UNITED STATES PATENT AND TRADEMARK OFFICE

APPLICATION NO.	FILING DATE	FIRST NAMED INVENTOR	ATTORNEY DOCKET NO.	CONFIRMATION NO.
10/812,370	03/29/2004	Andrew J. Tobler	IMI 40008	7611

Office Action Summary

NON-FINAL OFFICE ACTION

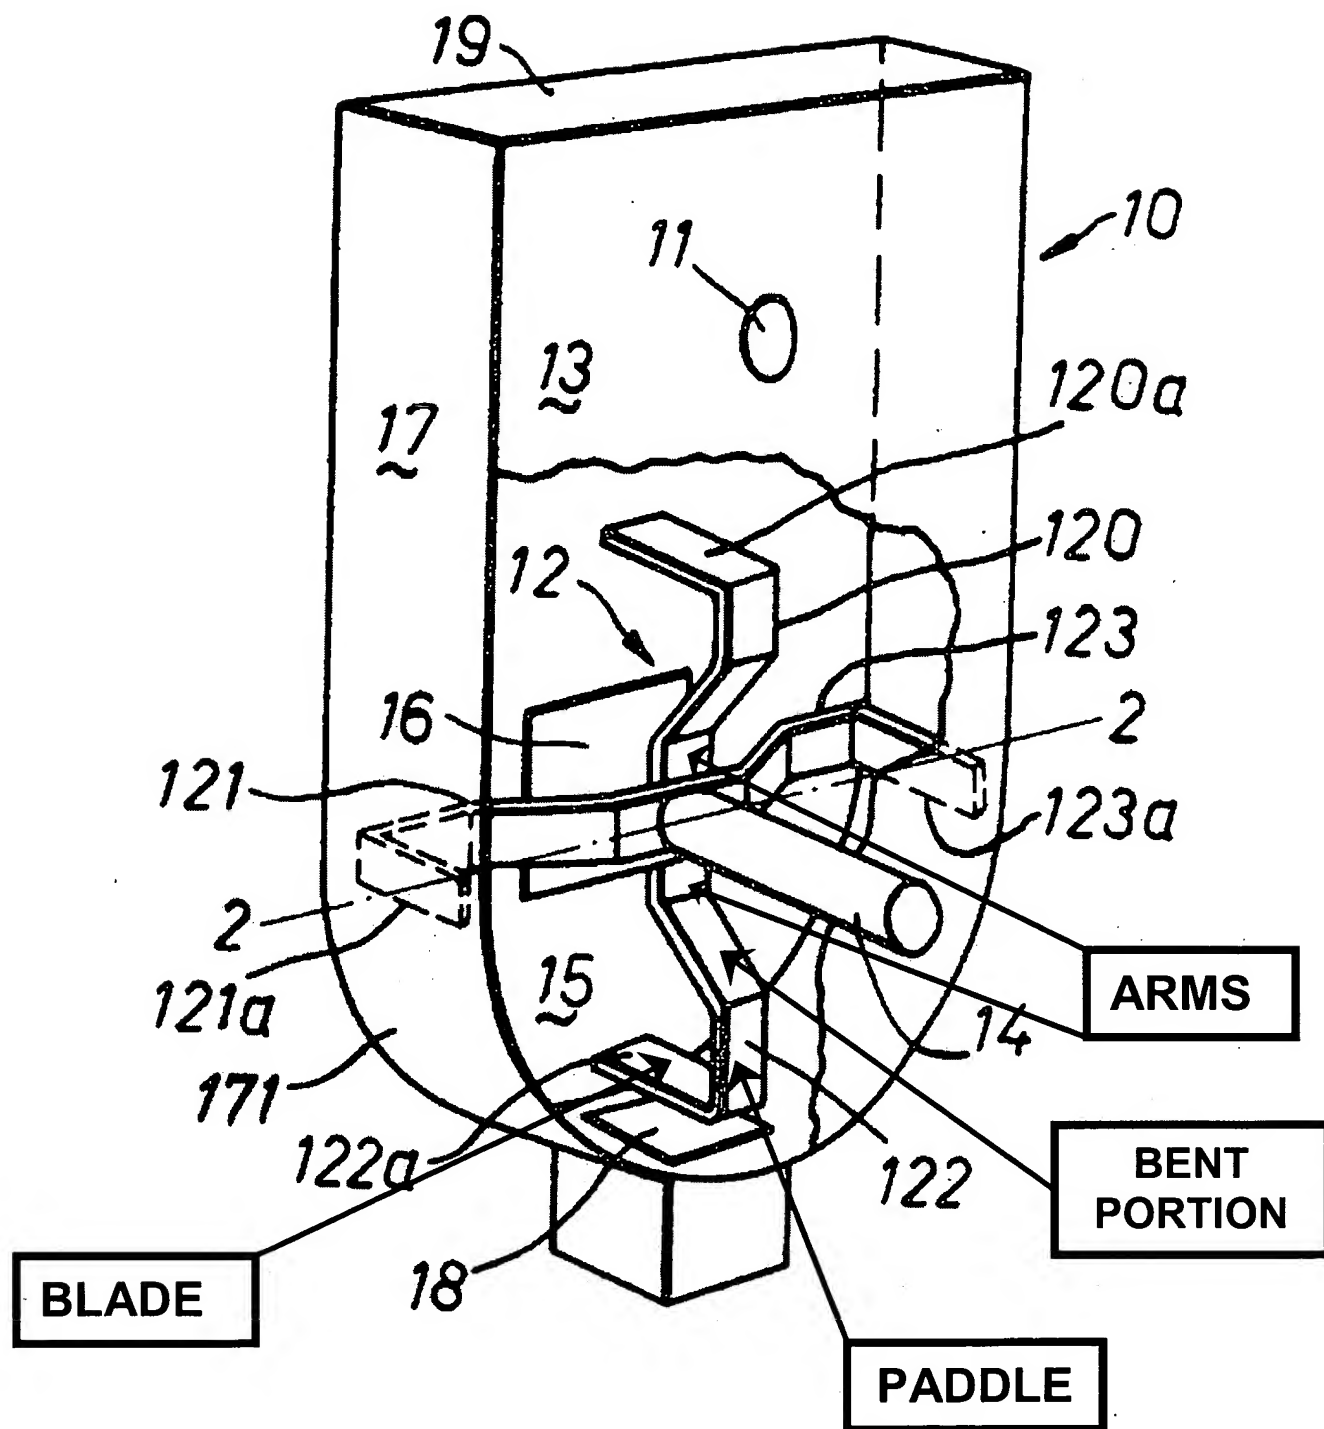
14. Claims 1, 2, 4, 5, 7, and 8 are rejected under 35 U.S.C. 102(b) as being anticipated by Kramer (US 4,087,079).

The patent to Kramer discloses the recited agitator as seen below including arms; hub 14; paddles 120, 122 attached to the arms by bent portions; blades 120a, 122a extending in a transverse direction out of a plane of the arms.

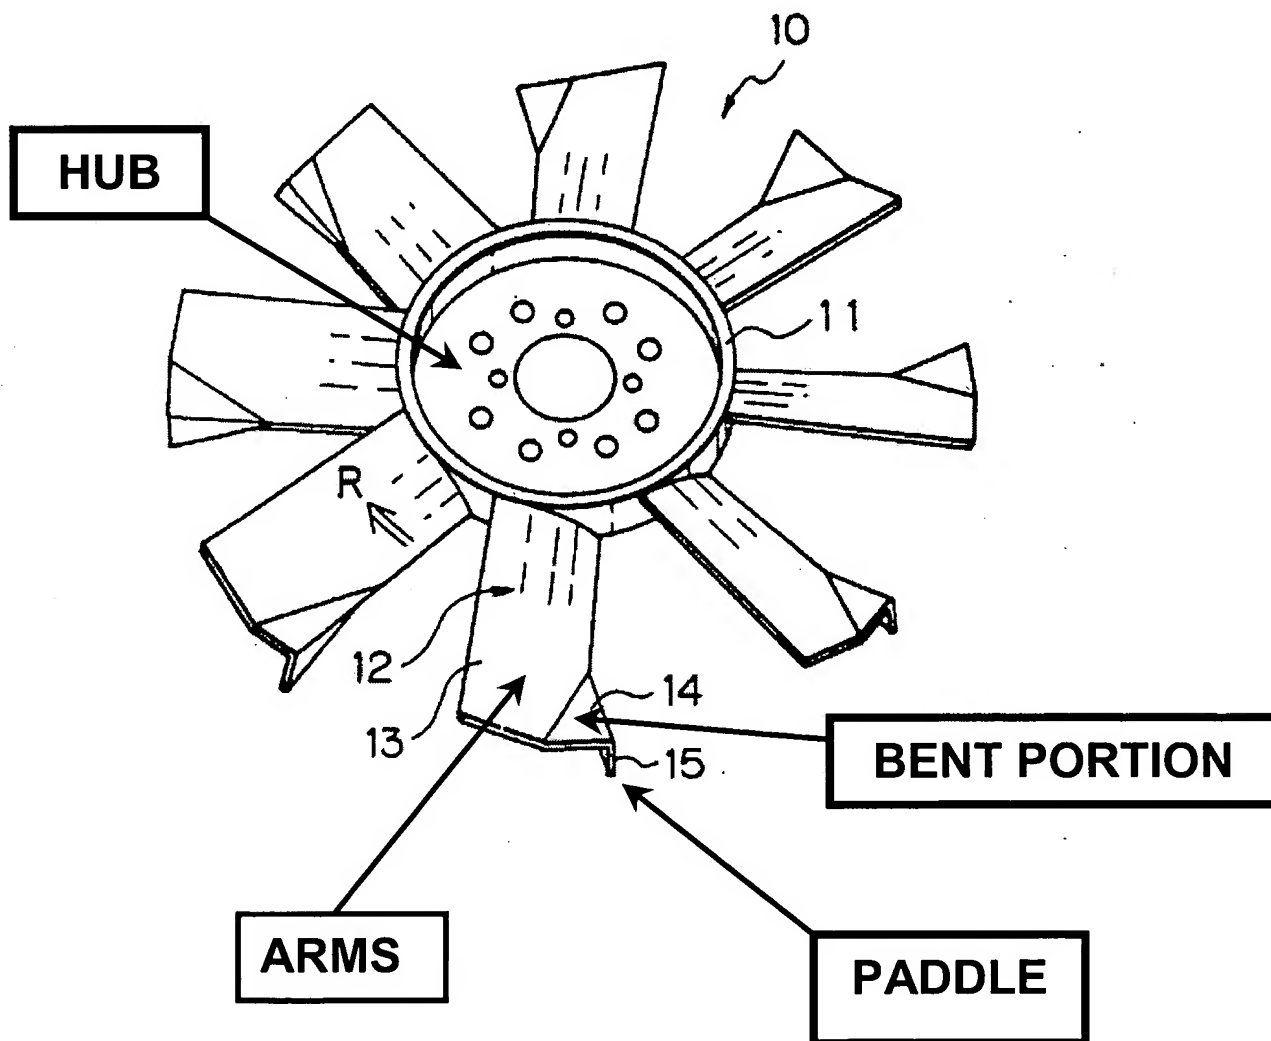
15. Claims 1 and 4 are rejected under 35 U.S.C. 102(b) as being anticipated by Mita (US 5,226,783).

The patent to Mita discloses the recited agitator as seen below including arms 13; hub; and paddles 15 attached to the arms by bent portions 14.

Fig. 4

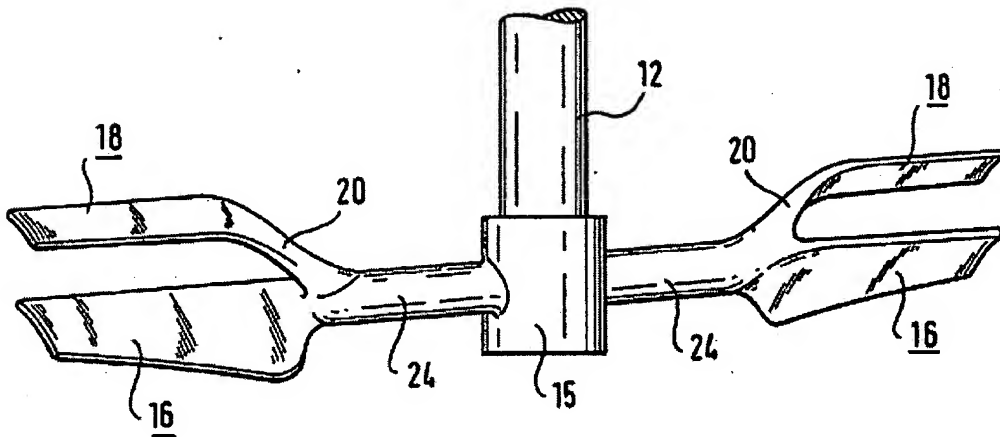
16. Claims 1, 2, 4, 5, 7, and 8 are rejected under 35 U.S.C. 102(b) as being anticipated by DE 3730423 A1.

DE 3730423 A1 discloses the recited agitator as seen below including arms 24; hub 15; paddles 18 attached to the arms by bent portions 20; and blades 16 extending in a direction out of a plane of the arms.
